UCRL-AR-113861 Add 1

**Addendum to the Pit 6 Engineering
Evaluation/Cost Analysis
Lawrence Livermore National Laboratory
Site 300**

November 1996

Figure 4. Proposed location of pit 6 cover and surface water diversion ditches.

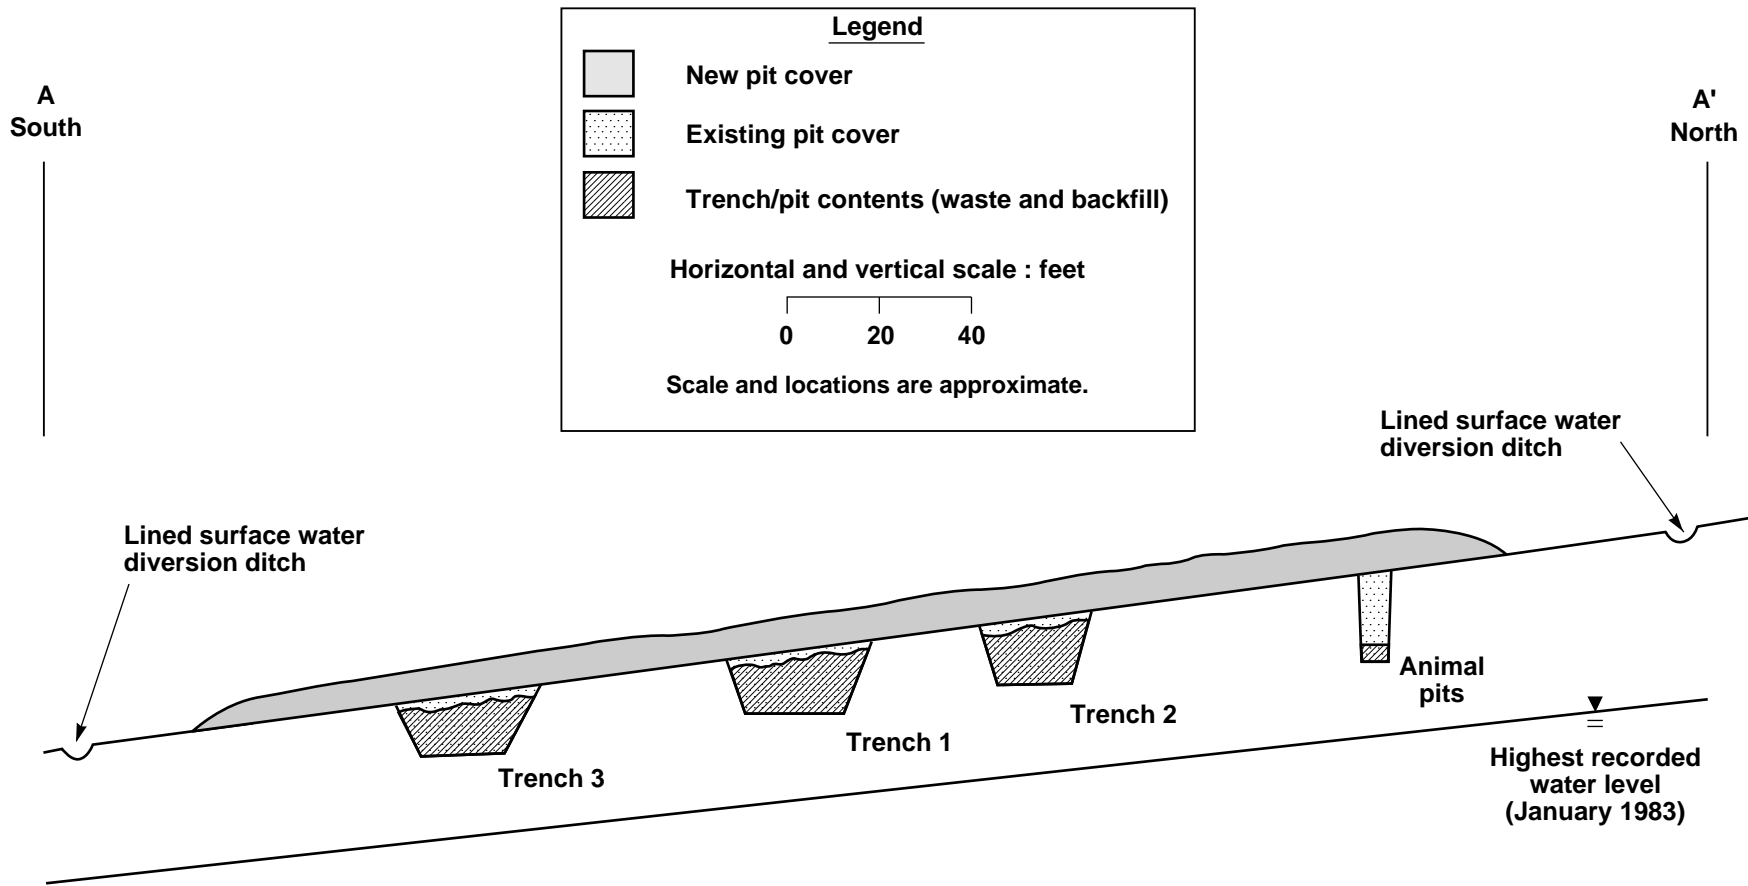
Alternative 2 of the EE/CA showed the landfill cover covering an area of about 63,000 ft² (1.5 acres). Further review of geophysical data and historical survey data suggests that some of the buried wastes may be located further east than was presented in the SWRI. The uncertainty of the buried waste contents, potential for void space collapse under heavy equipment, and access restrictions preclude better definition of the areal extent of the buried waste. Therefore, the areal extent of the proposed landfill cover has been expanded to approximately 2.4 acres. Figure 4 shows the proposed expanded area for the landfill cover, as well as revised locations of the buried waste. Surface water drainage outfall has also been changed to drain to the south and the southwest of the landfill cover instead of only to the southwest.

Figure 5. Conceptual south-north cross section showing proposed location of pit 6 cover.

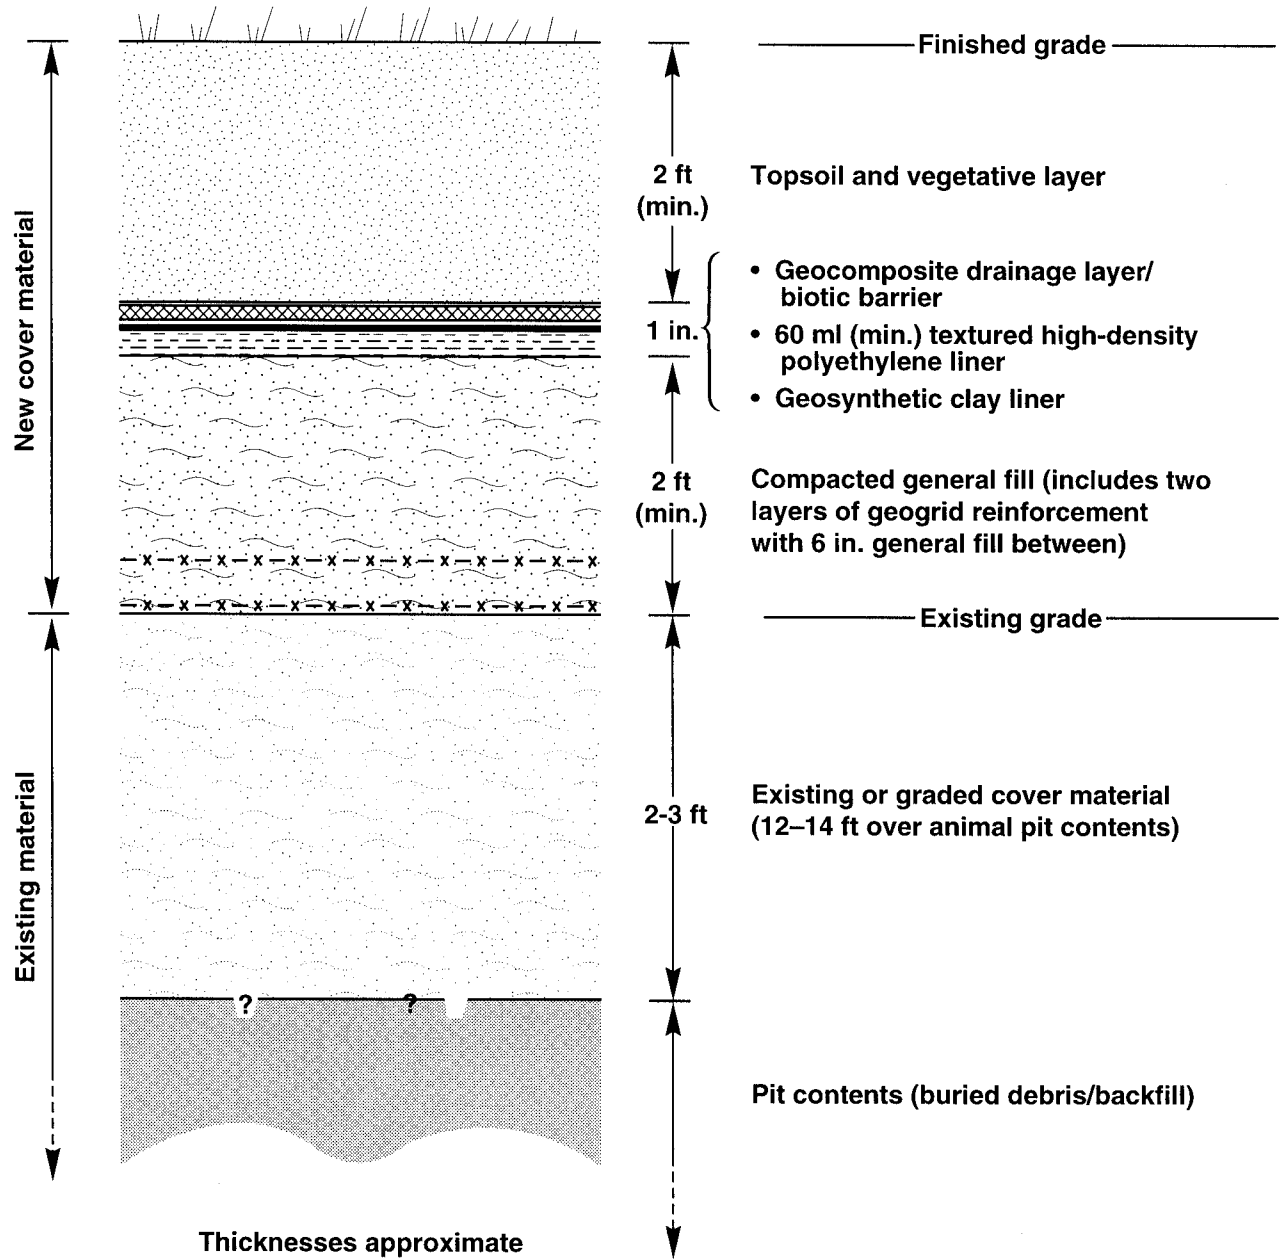
Figure 5 shows a conceptual cross section of the landfill cover in relationship to the buried waste.

Figure 7. Ground water monitoring network — revised Alternative 3.

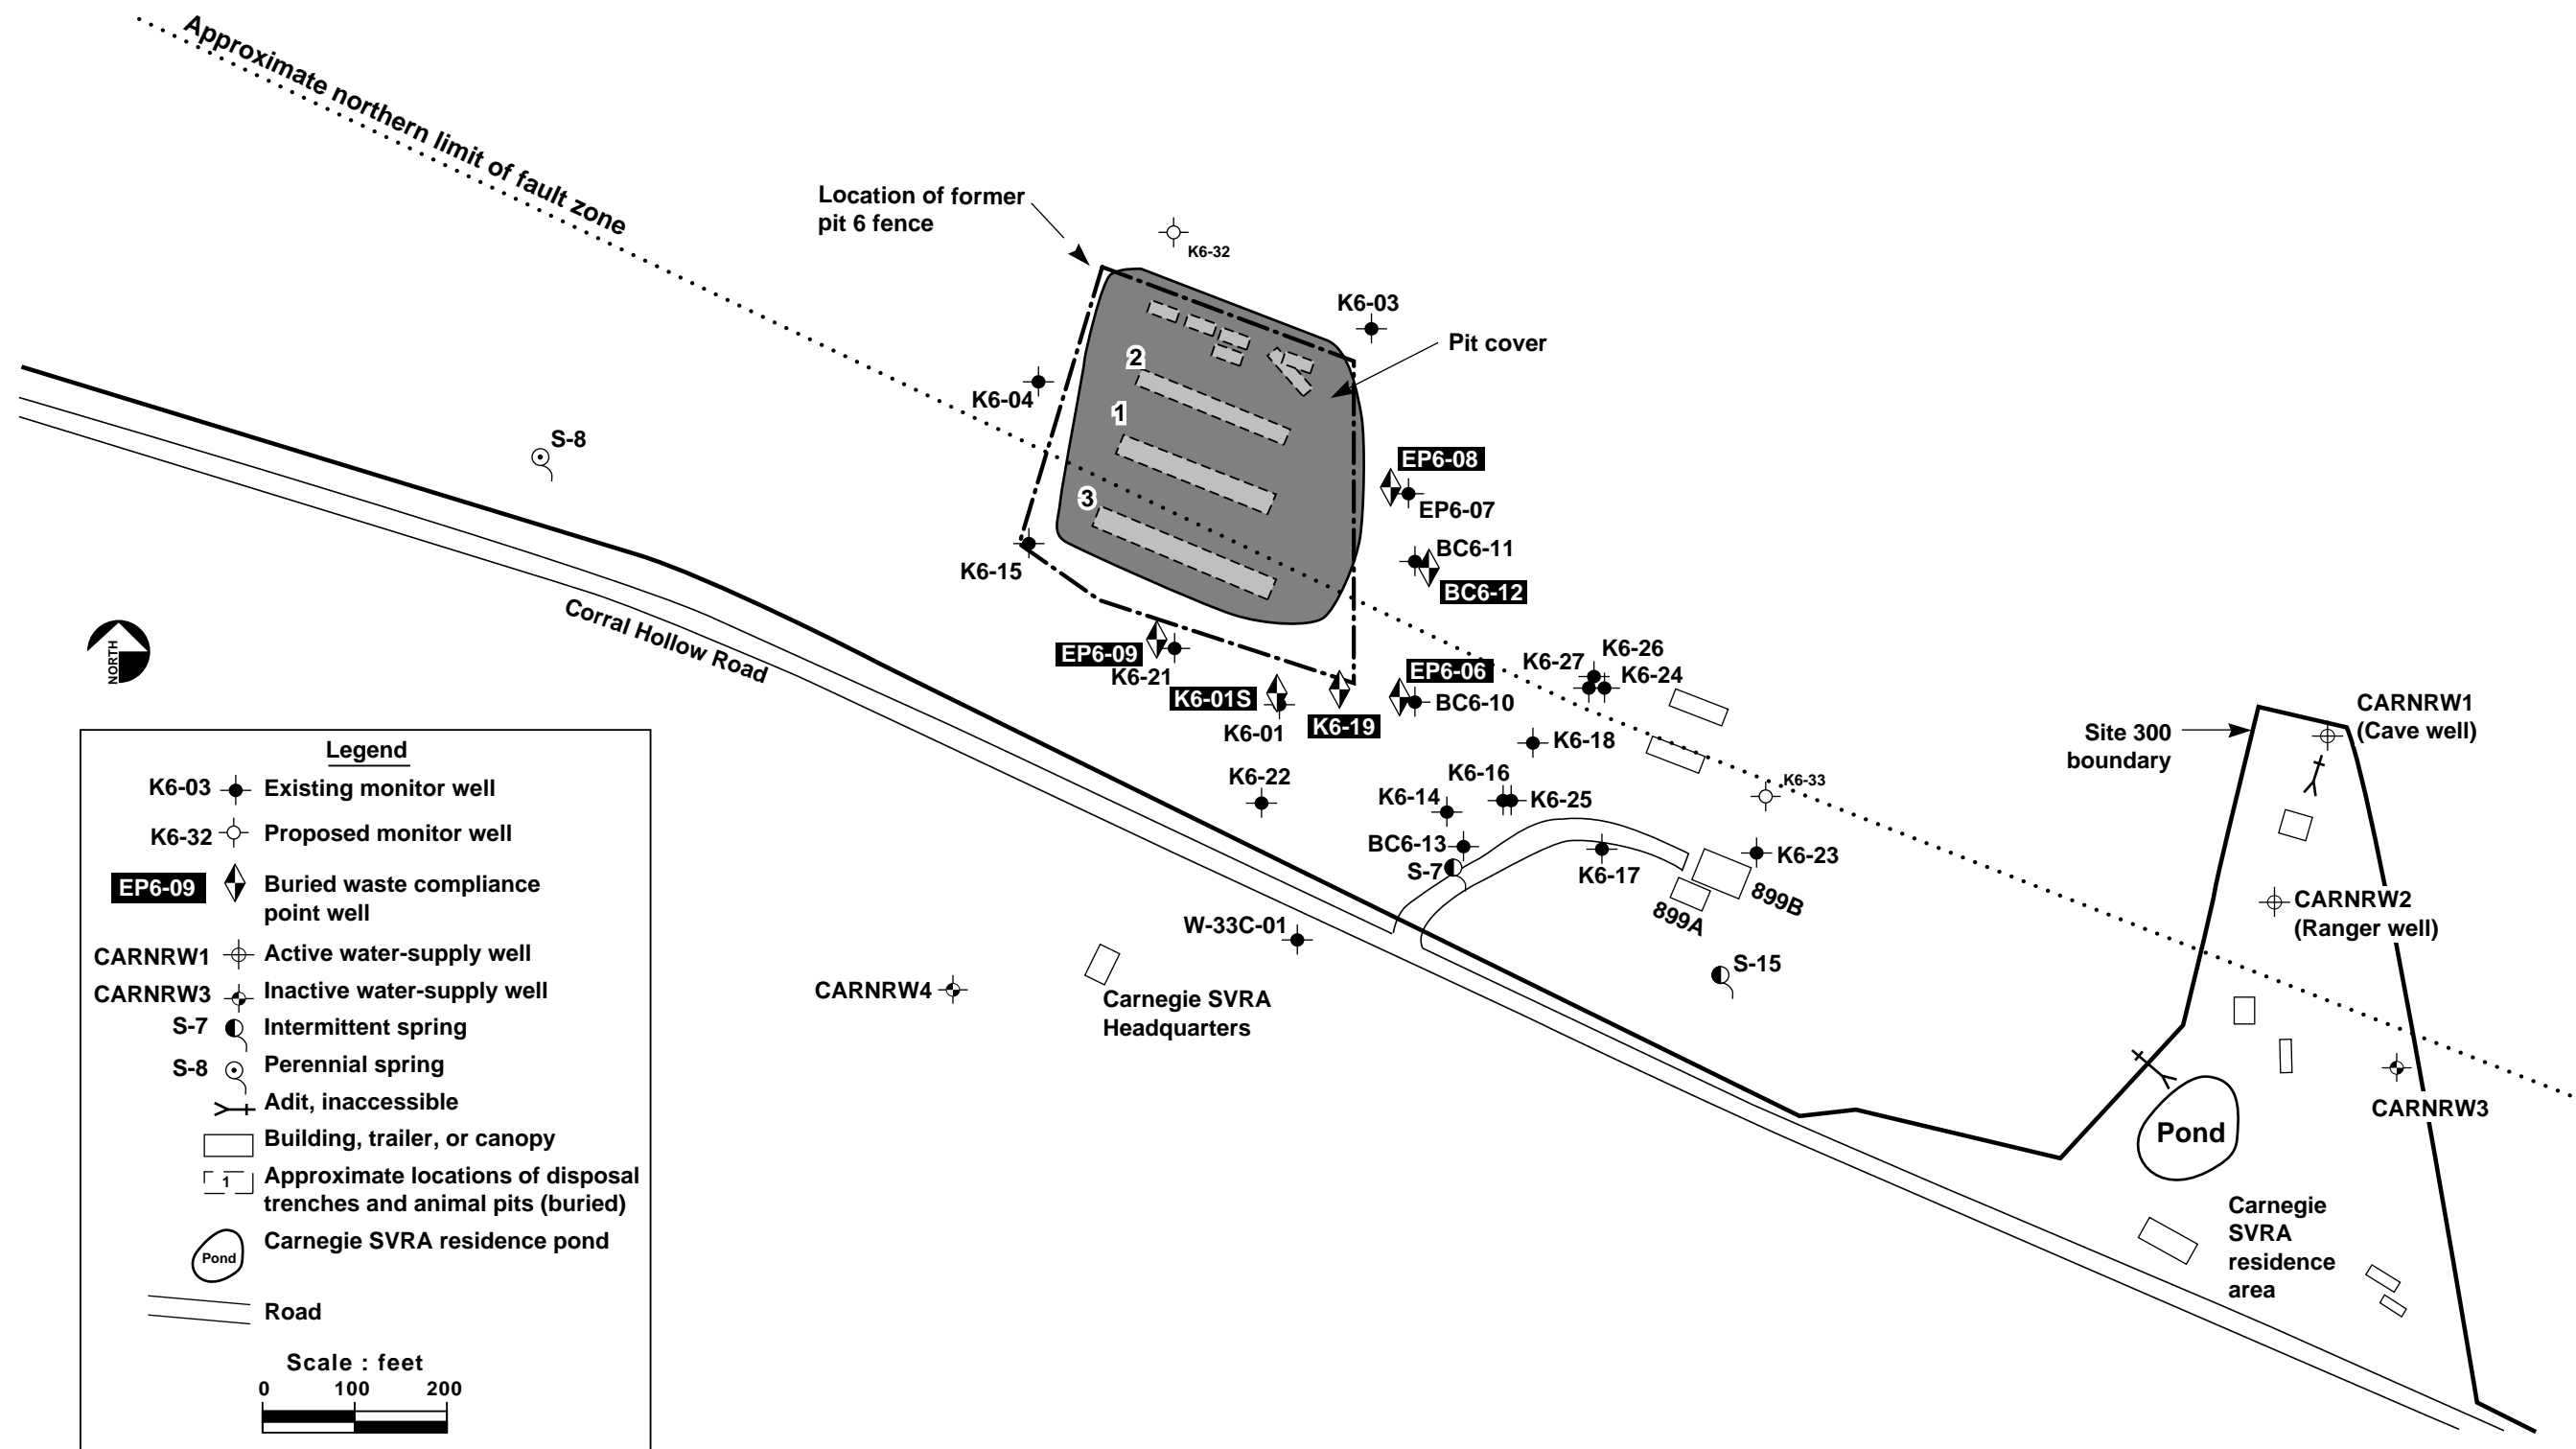
Figure 7 shows the ground water monitoring network for revised Alternative 3. The ground water monitoring plan reflects two objectives:

Six proposed ground water monitor wells located in the buried waste area described in the EE/CA (wells P6-01 through P6-06) have been reduced to one proposed new well, K6-32 (formerly P6-06). Well K6-32 will be installed immediately upgradient of the landfill cover near the northwest corner (Fig. 3) to provide a location for monitoring water elevations and background concentrations. Wells P6-01 through P6-05 will not be installed because:

Proposed monitor well K6-33 has been moved about 200 ft east of its initially proposed location. It is downgradient of well K6-18 and will monitor the shallow ground water plume along the gravel channel (Qt) depicted in Figure 1-19 of the EE/CA. Because the Qt is shallow and only a few feet thick at this location, the screen for K6-33 will probably need to extend into the underlying bedrock to reach below the water table. If VOCs are detected in K6-33, another shallow monitor well, and possibly a deeper monitor well, may be installed further downgradient.

Figure 8. Potential locations of contingency ground water extraction and treatment system and related monitoring network — revised Alternative 3.

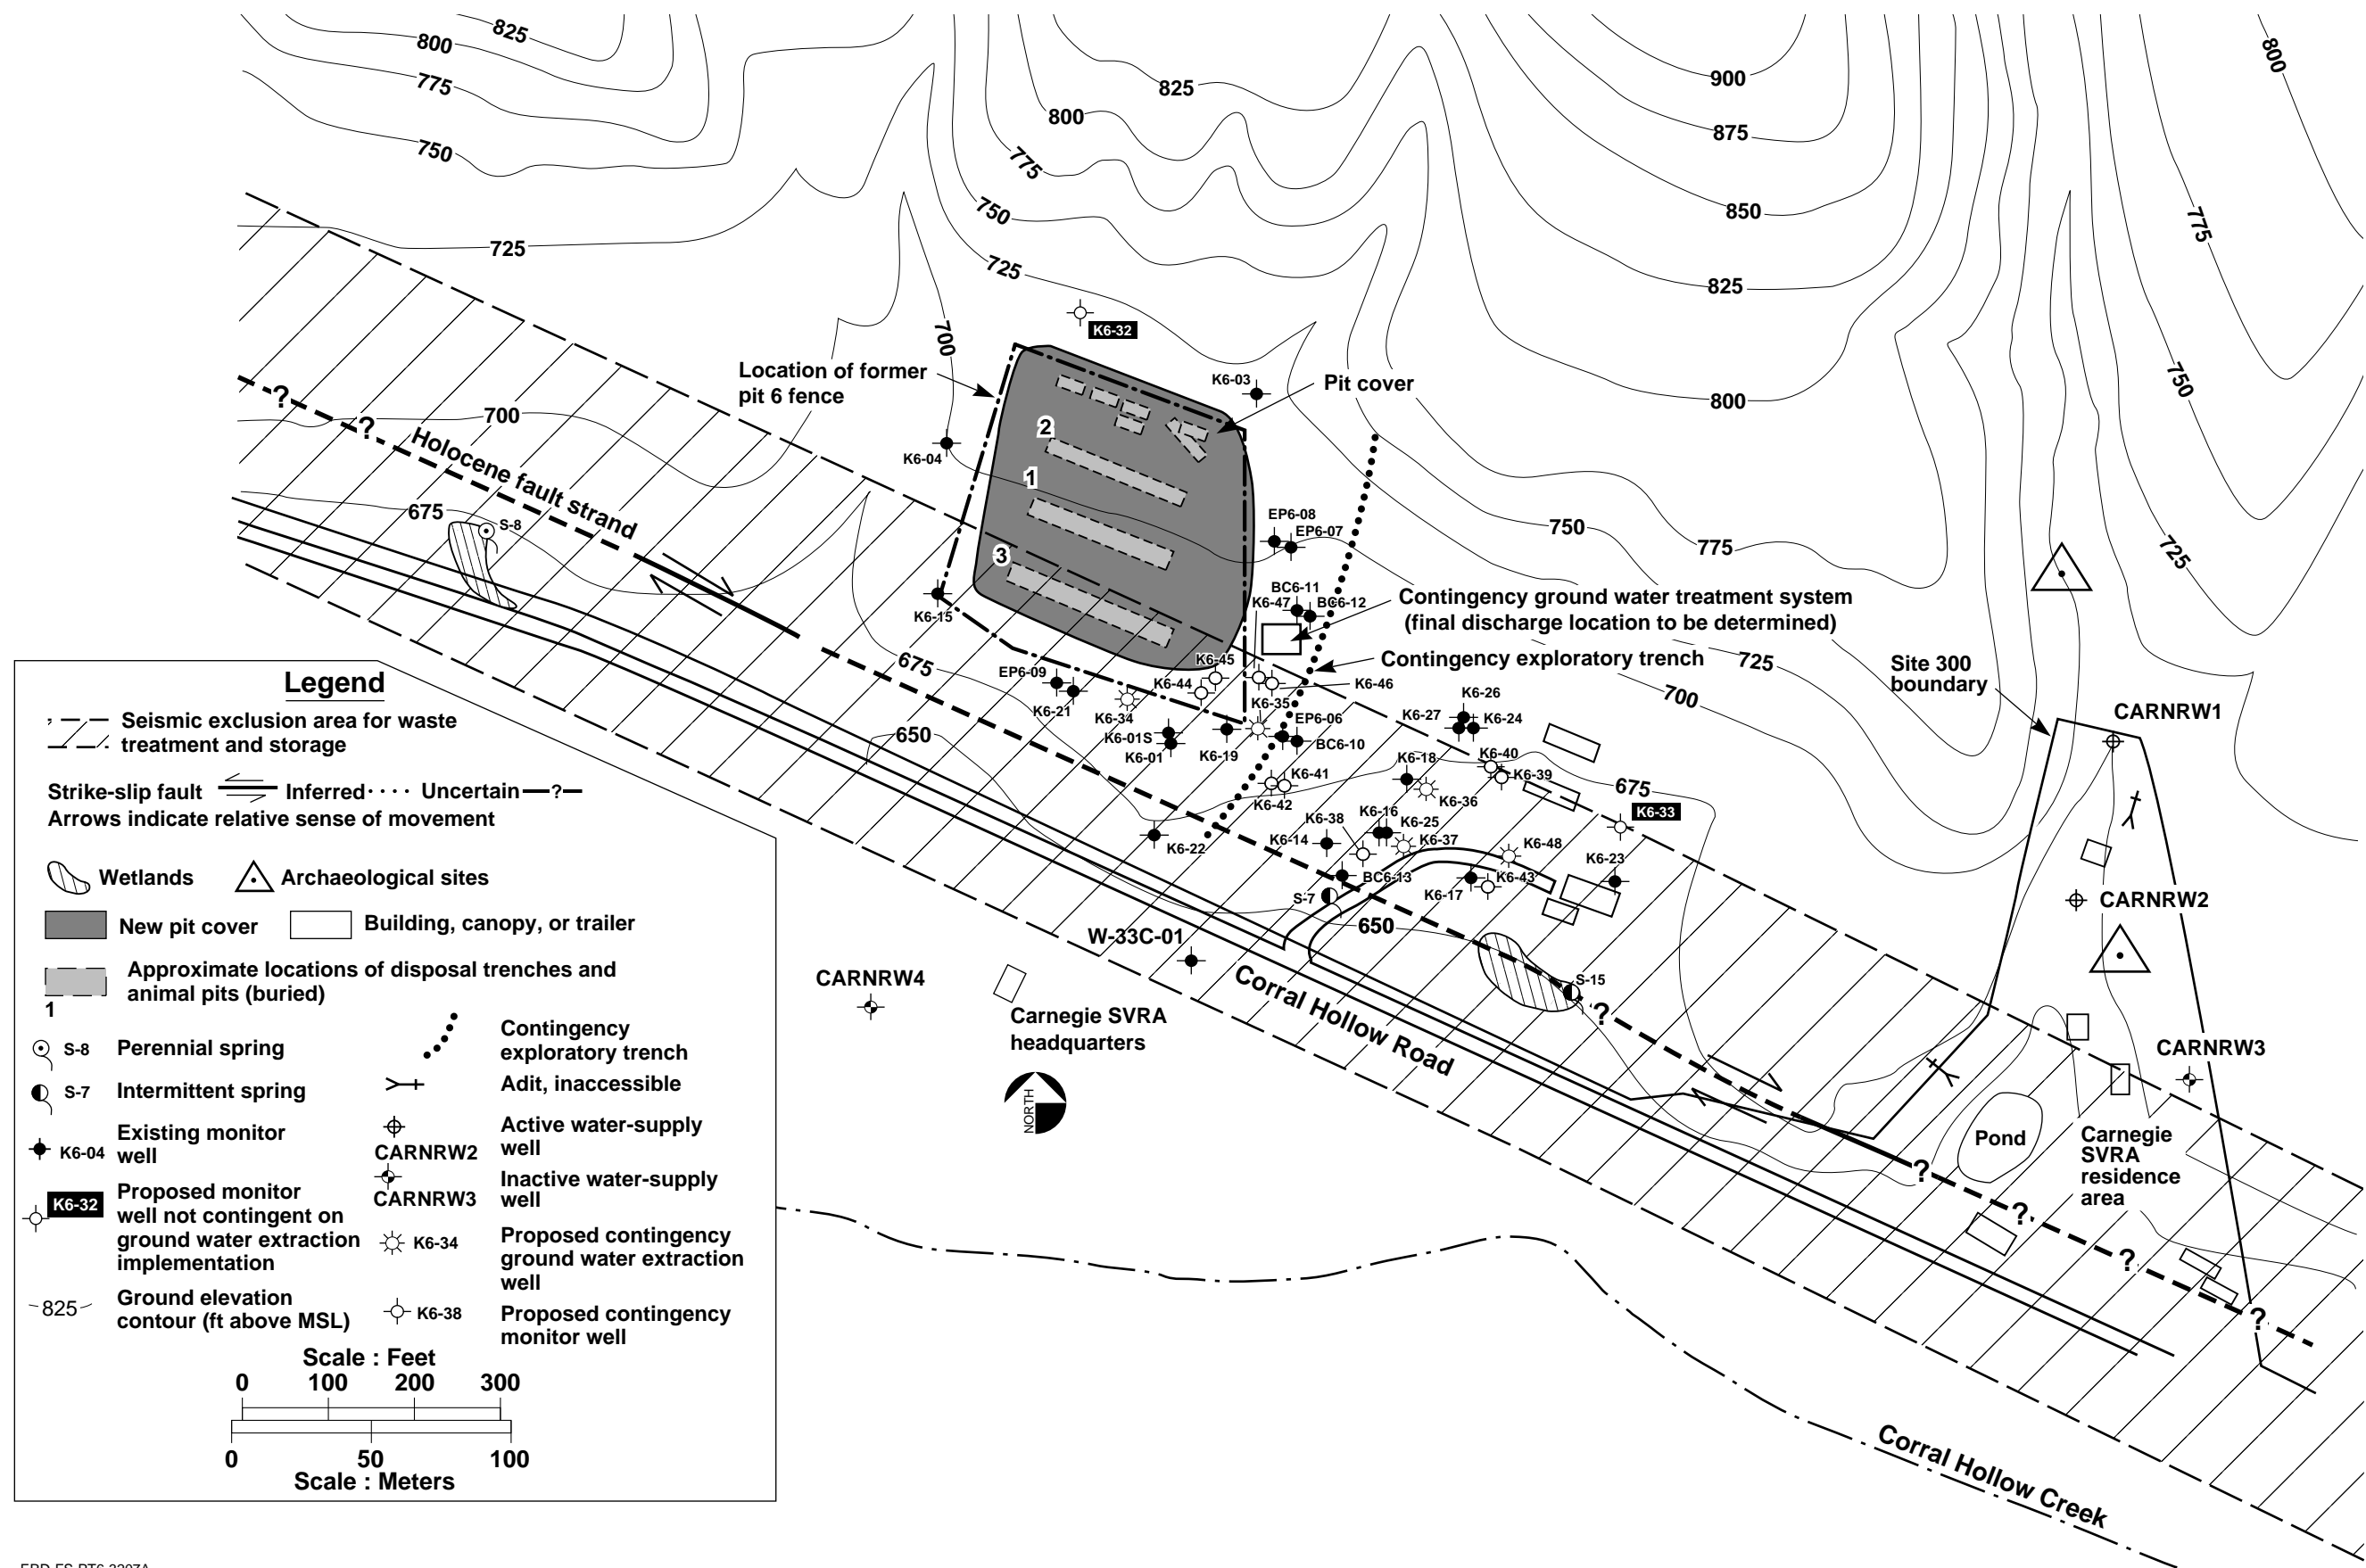
Figure 8 shows the proposed locations for the contingency ground water treatment system and associated extraction and monitor wells. The installation schedule, and the number and location of wells would be re-evaluated at the time of actual design. The seismic exclusion zone and

exploratory trench shown on Figure 8 are related to a location-specific limiting proximity of the ground water treatment system to the Holocene strand of the Carnegie Fault system.
